1865 WOODMOOR DRIVE

LANDSCAPE PLAN

PPR1830

LANDSCAPE PLAN NOTES & DETAILS

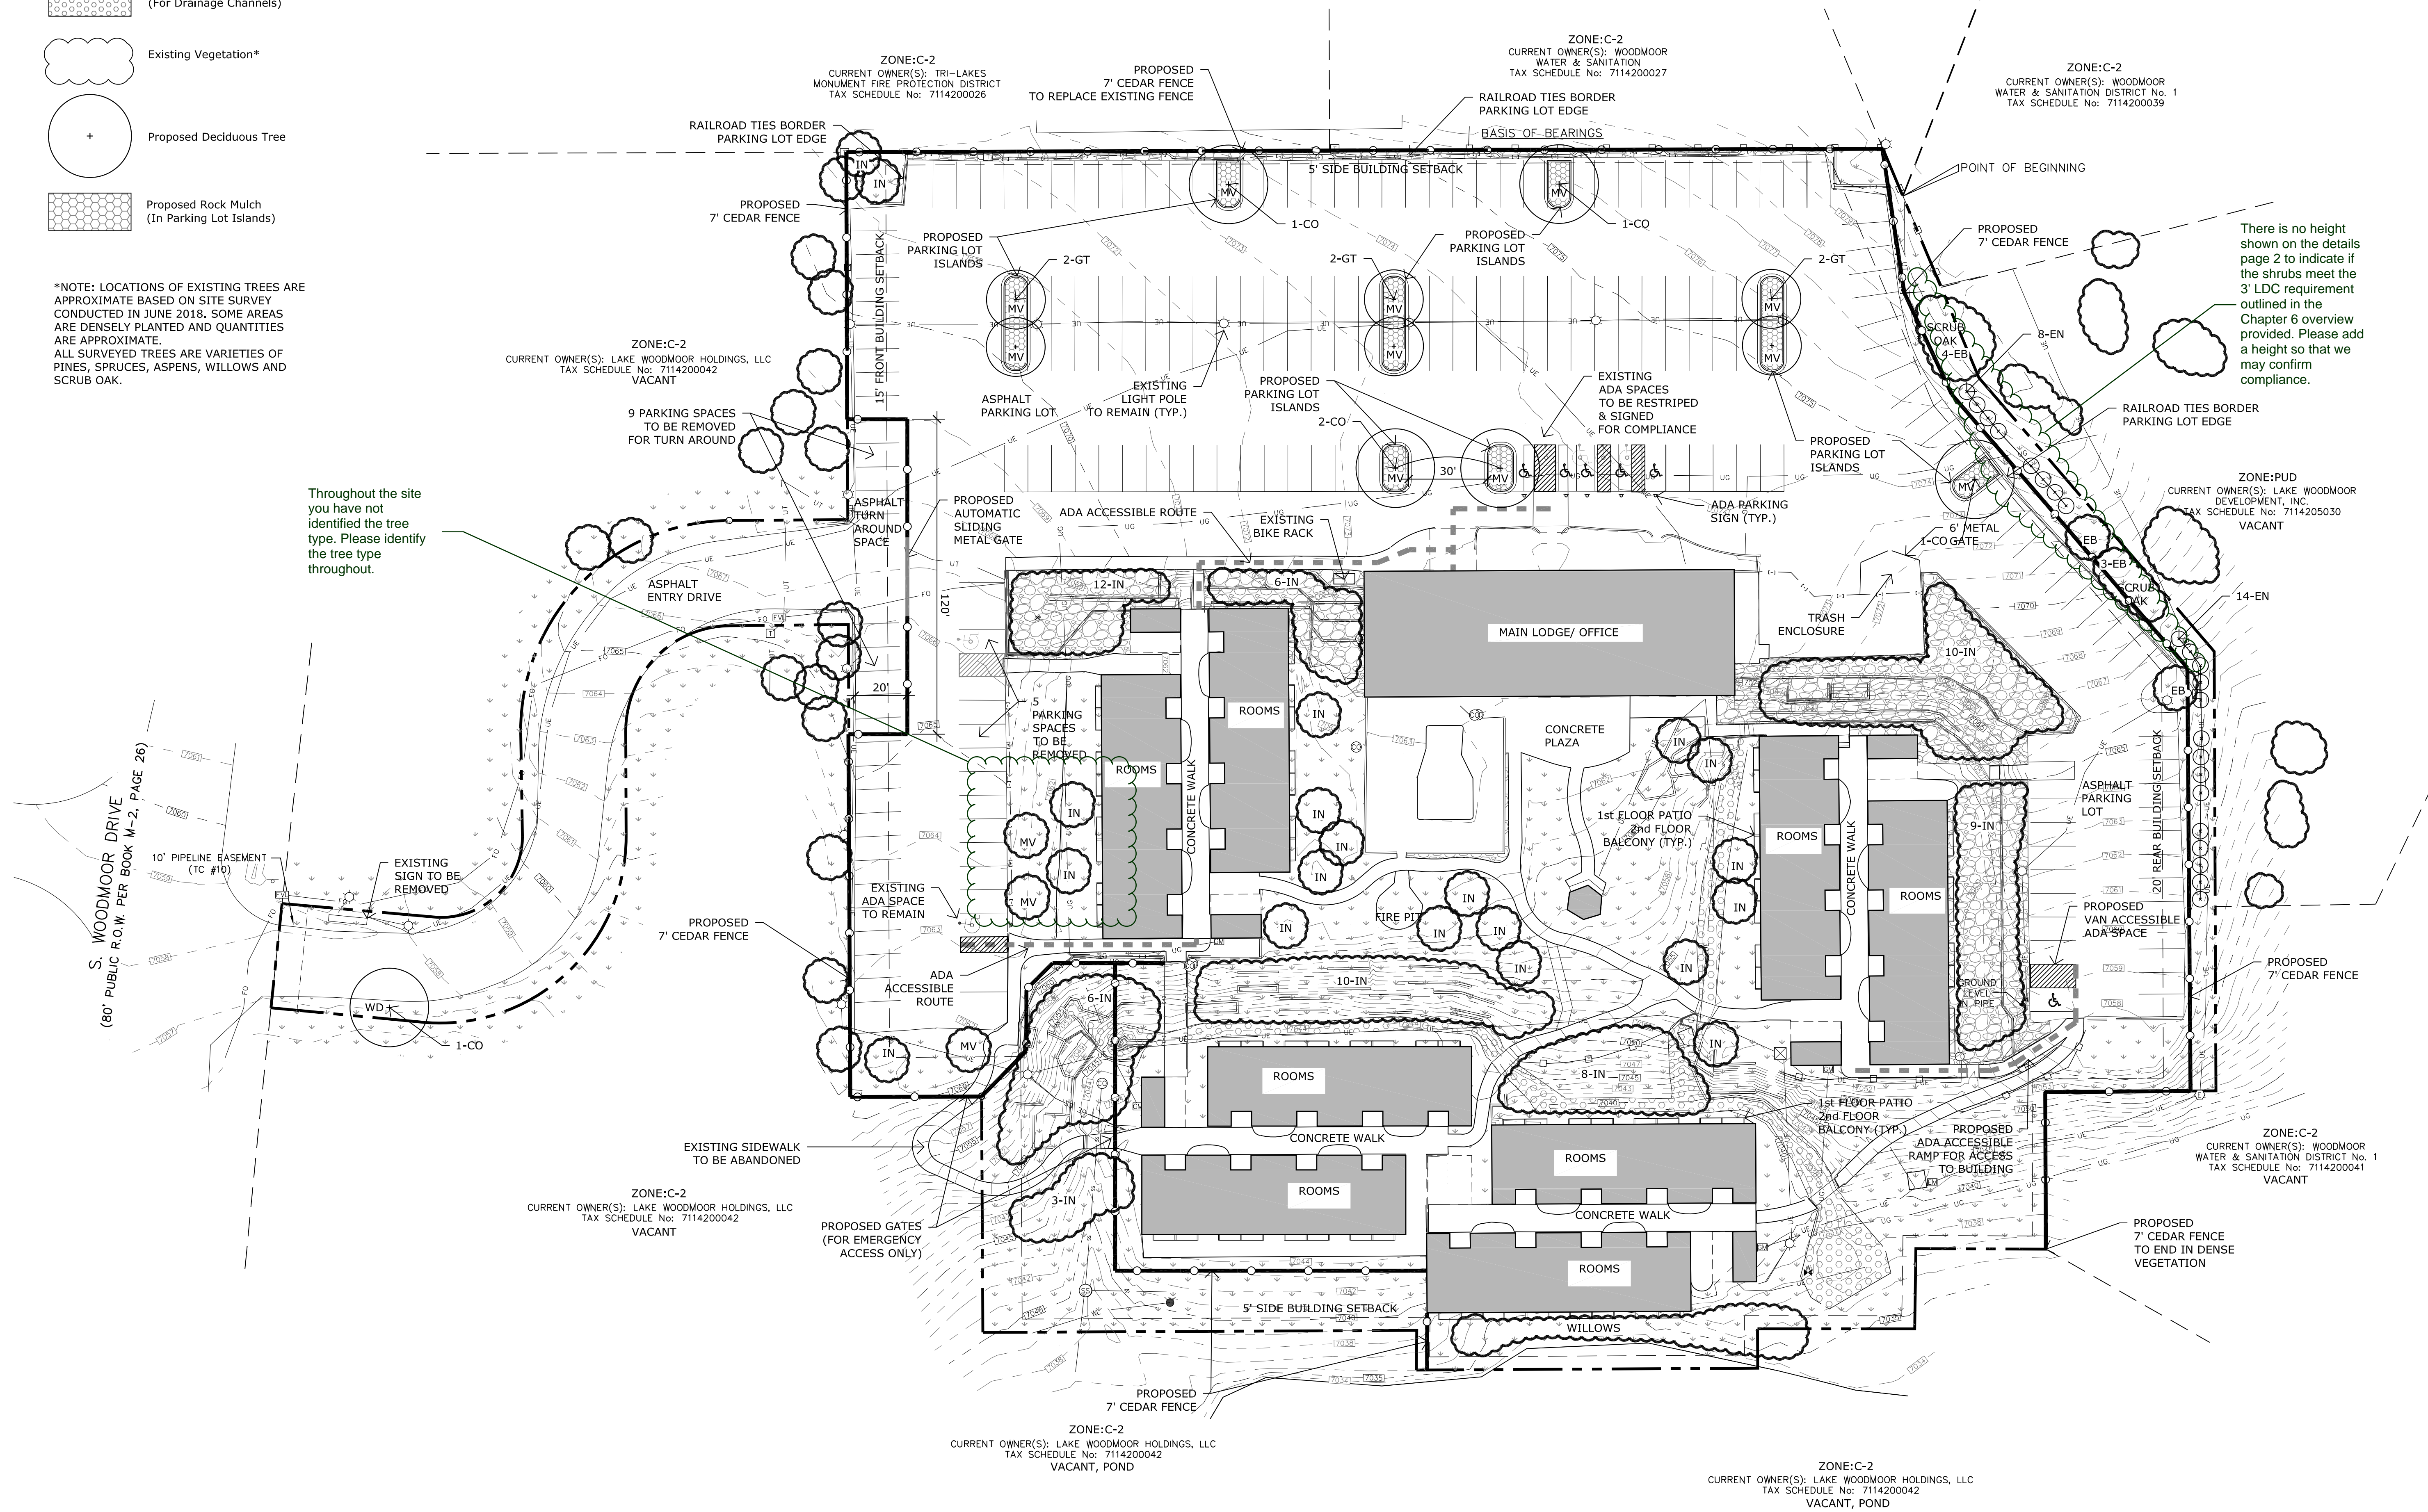
Throughout the site you have not identified the tree type. Please identify the tree type throughout.

There is no height shown on the details page 2 to indicate if the shrubs meet the 3' LDC requirement outlined in the Chapter 6 overview provided. Please add a height so that we may confirm compliance.

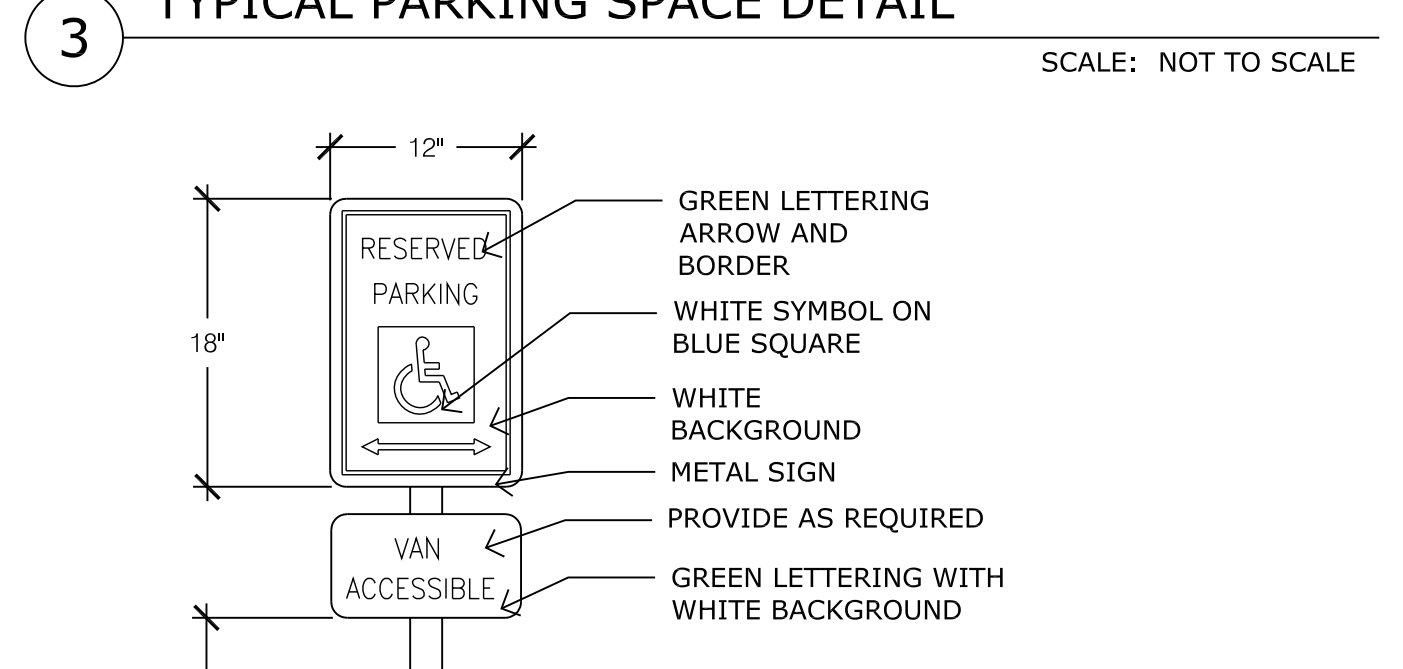
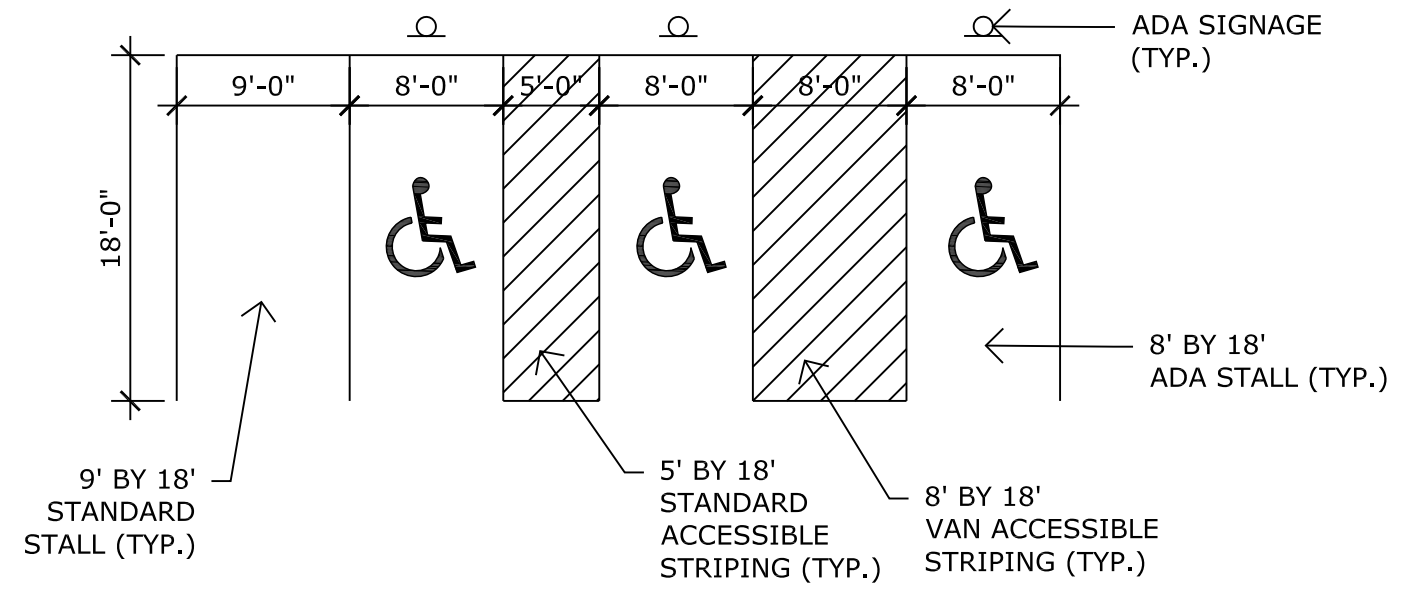
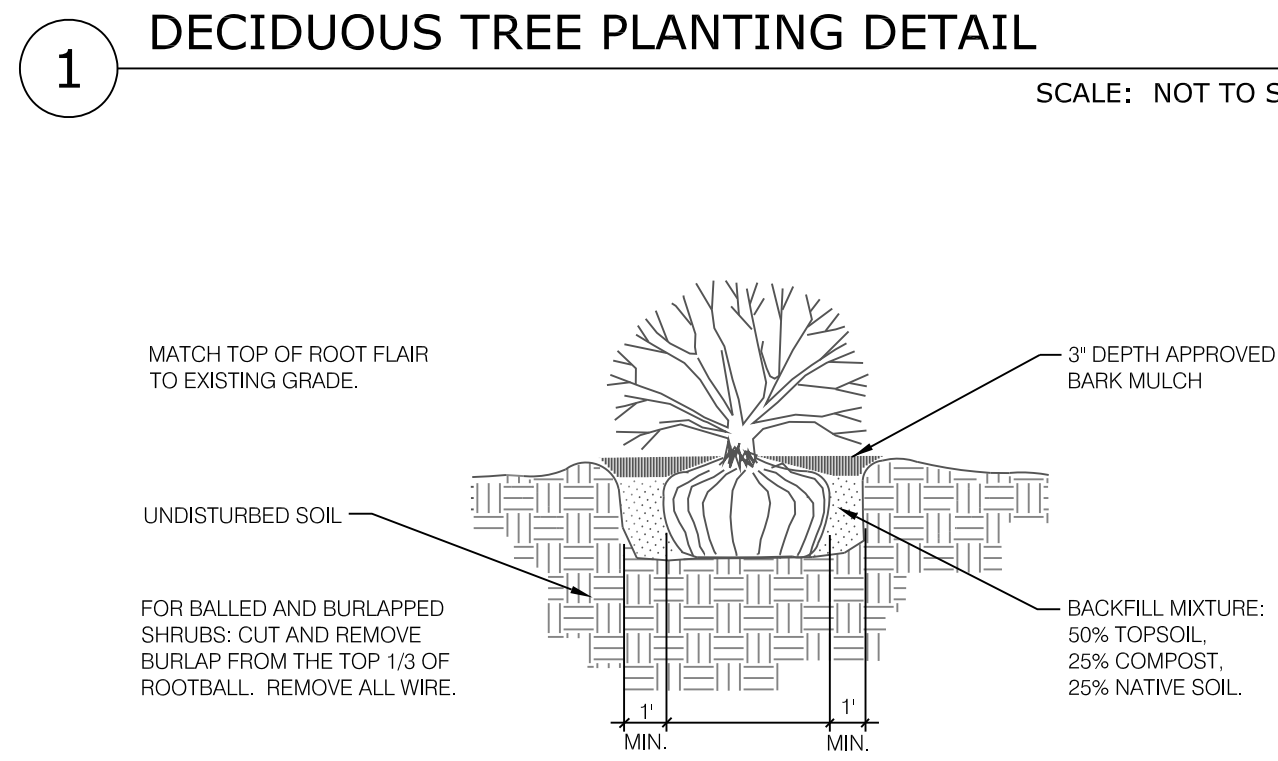
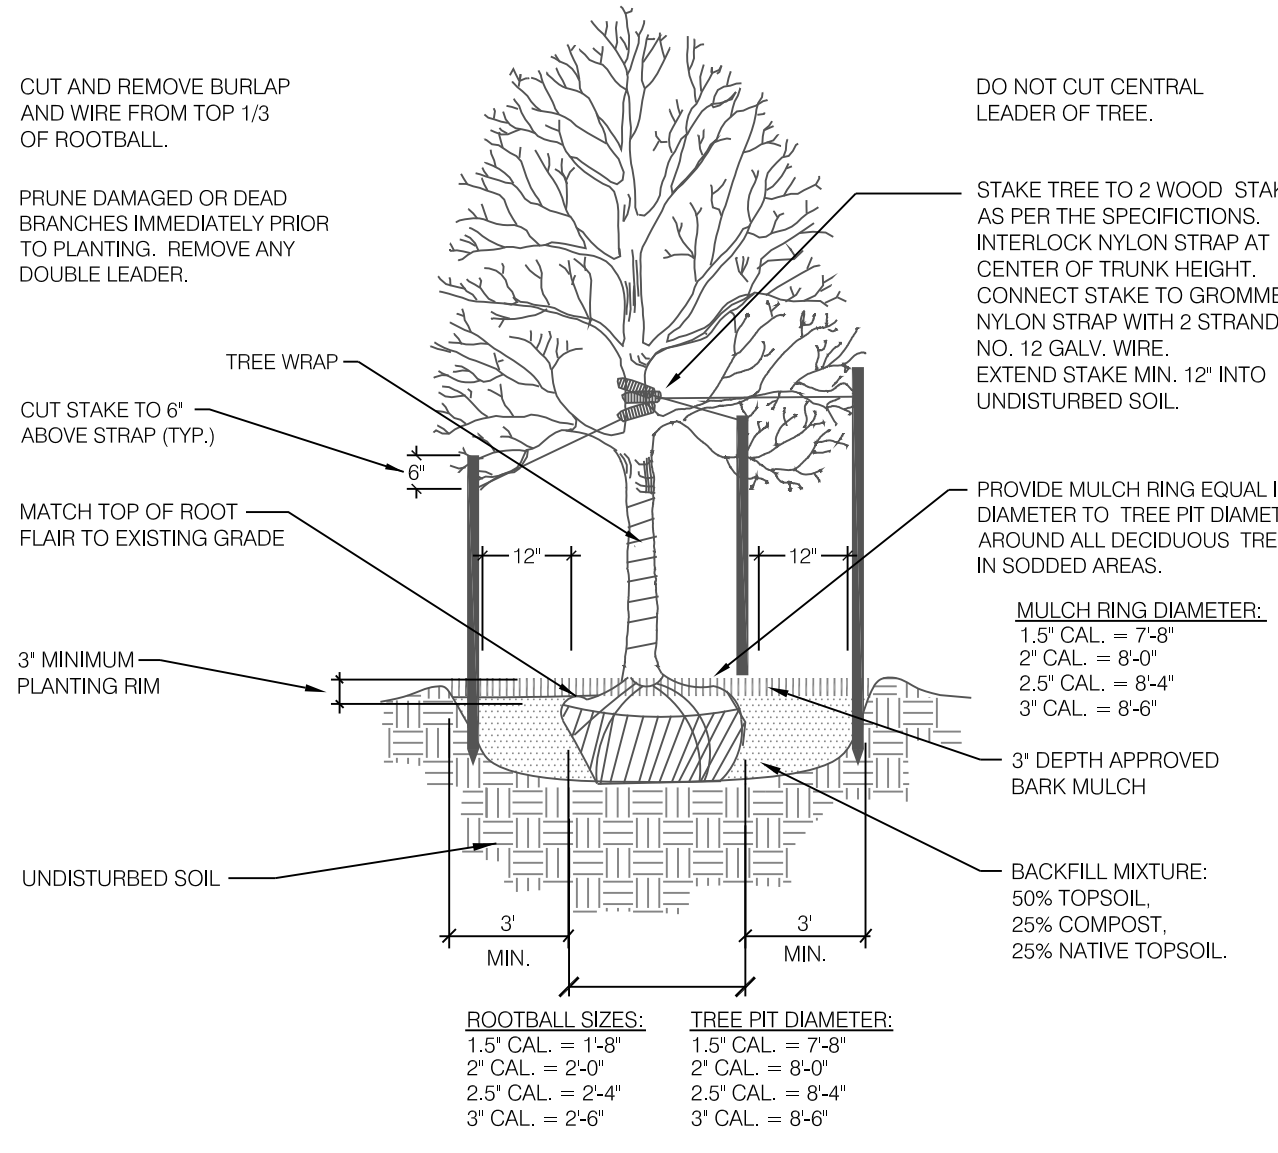
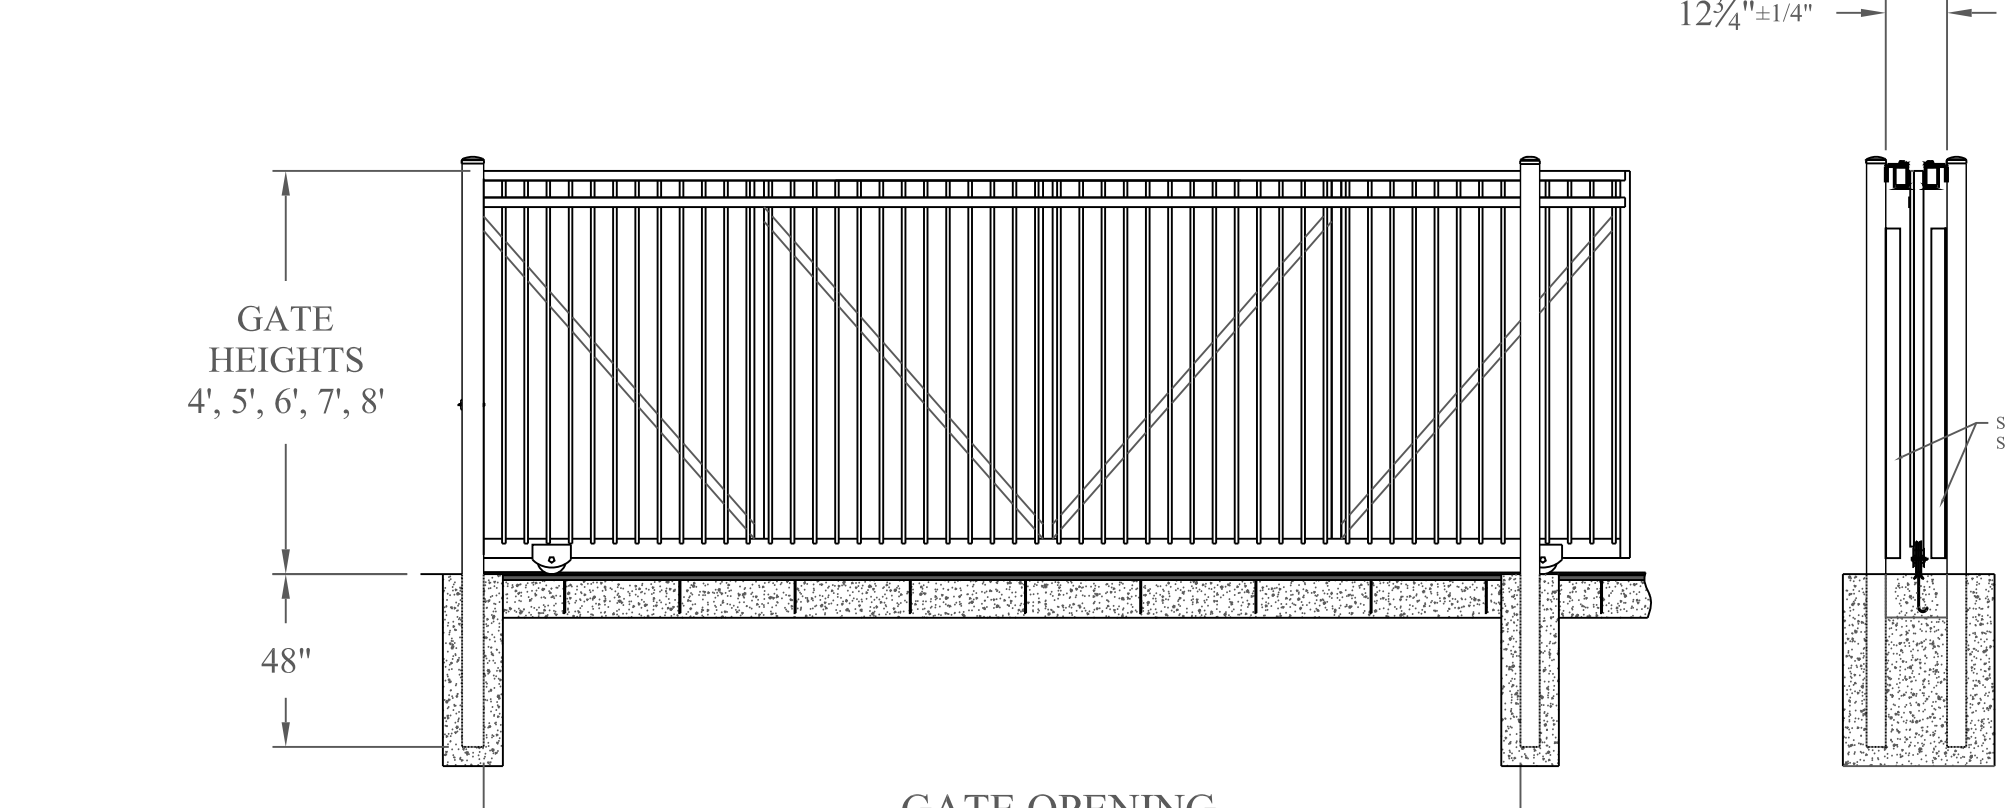
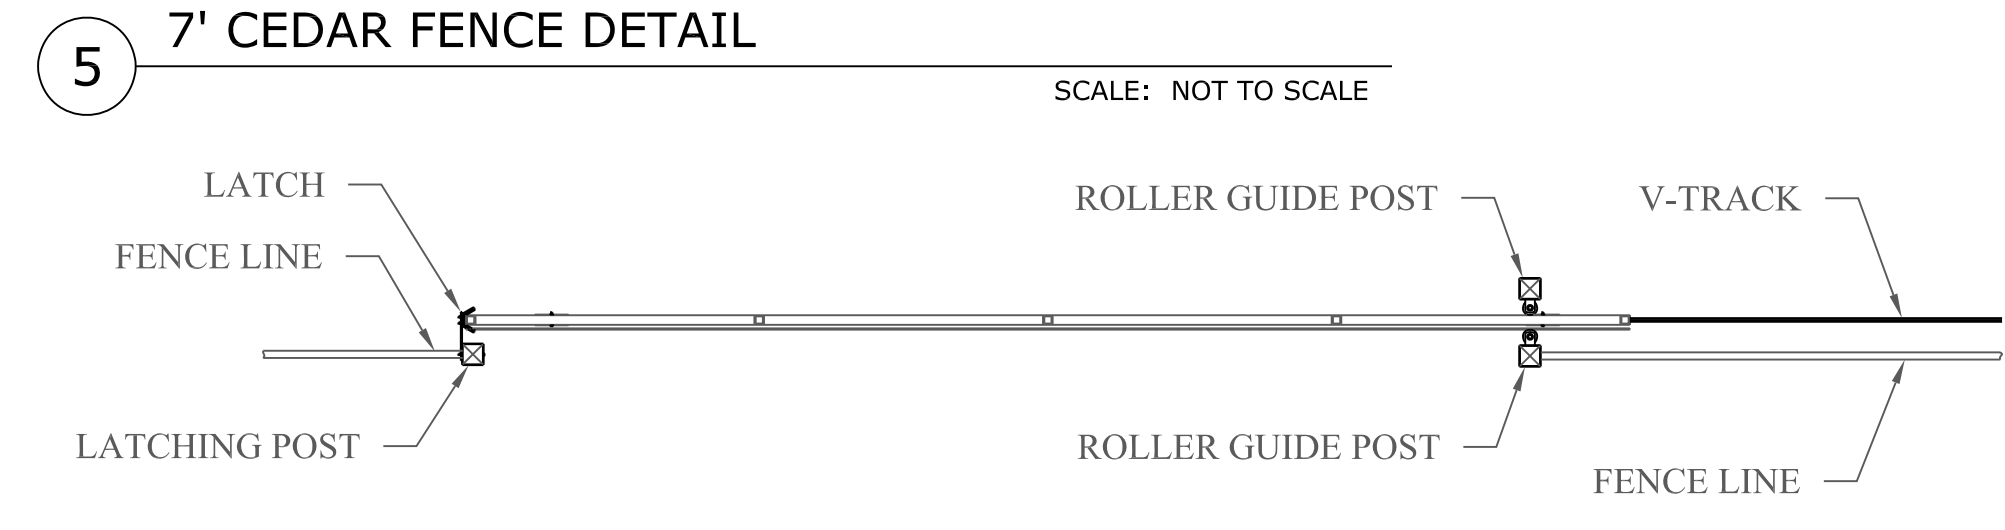
Please provide a side elevation of the trash enclosure.
